Hardware Improvements to Motherboard and Power Supply

TWOx12 / TWO / 2101 Studio Interface & Extended Hybrid

January 2008, Cleveland Ohio, USA

This bulletin is for the purpose of informing you about issues and improvements we have made that may affect your Telos TWOx12, TWO, and 2101 Studio Interface and Extended Hybrid.

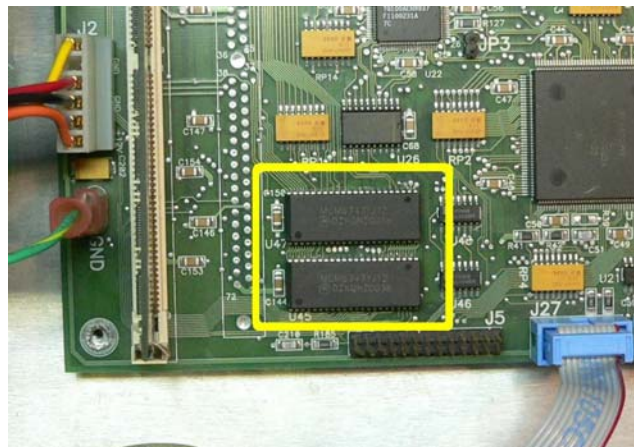
A visual inspection of your units' power supply will let you know if you have the current version or not. There are 6 large caps behind the 8-pin Molex connector. The brand on those caps should say "Nichicon". Any other brand caps are unacceptable. Also, on the new supply 2 of these 6 caps are 1cm higher than any other cap on the supply. See the picture below:

If any of your units do not have this new style supply please contact customer support at the above phone or email. We can either ship you a free replacement supply or we can schedule your unit for a quick repair in our shop.
